# HISTORIC AND DESIGN REVIEW COMMISSION

**HDRC CASE NO:** 2018-313  
**COMMON NAME:** 410 S MAIN  
**ADDRESS:** 307 DWYER AVE  
**LEGAL DESCRIPTION:** NCB 173 BLK LOT 1-2, S IRREG 39 FT OF 3 & 14  
**ZONING:** D  
**CITY COUNCIL DIST.:** 1  
**APPLICANT:** James West/GFF Architects  
**OWNER:** Delta Main & Dwyer LLC  
**TYPE OF WORK:** Amendments to a previously approved design  
**APPLICATION RECEIVED:** June 15, 2018  
**60-DAY REVIEW:** August 14, 2018  
**REQUEST:**

The applicant is requesting a Certificate of Appropriateness to amend the previously approved design to construct a five story, 327 unit, multi-family residential structure at 410 S Main and 307 Dwyer Avenue. This lot is zoned Downtown. The applicant has proposed modifications to the original design to include an additional floor in height on the north side of the lot as well as modifications to previously approved materials and architectural elements.

SOUTH ELEVATION

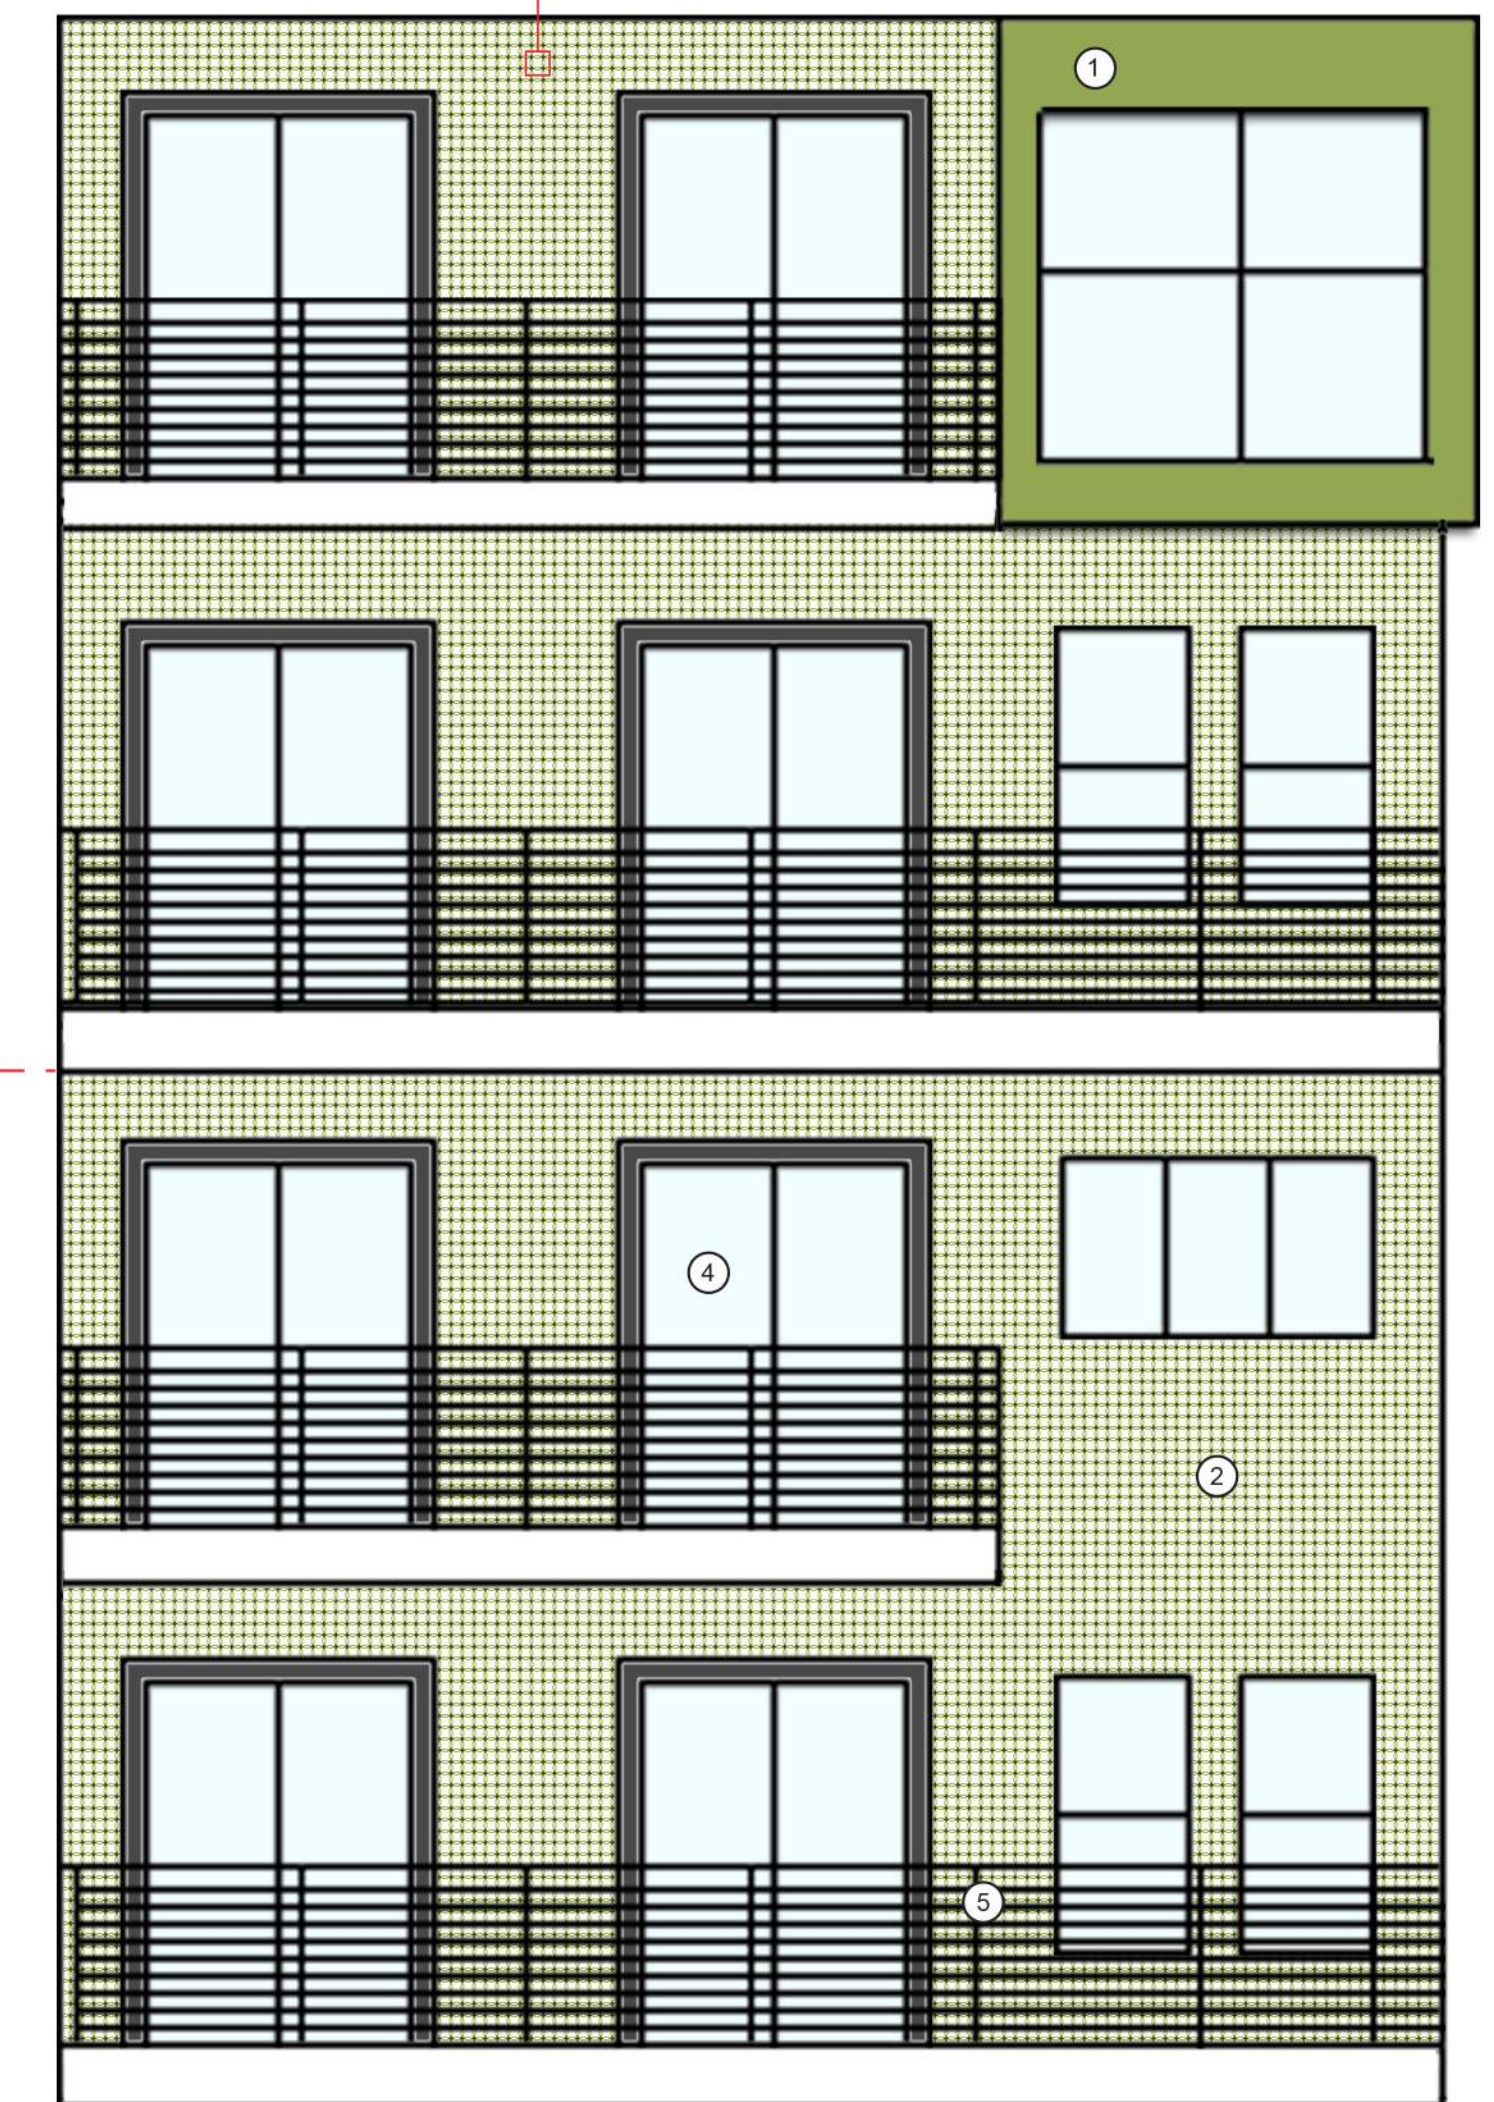
- g. **ARCHITECTURAL DETAILS** – The Downtown Design Guide requires for each structure to feature a base, midsection and cap. Staff finds that the proposed design includes both a base and mid-section; however, staff finds that a more substantial building cap should be included. Staff finds that a more defined cornice or a change in materials would be appropriate

- i. That a more substantial building cap be installed through additional cap massing and/or a change in materials or color.
- ii. That window frame color be presented to staff. White windows are not to be used.
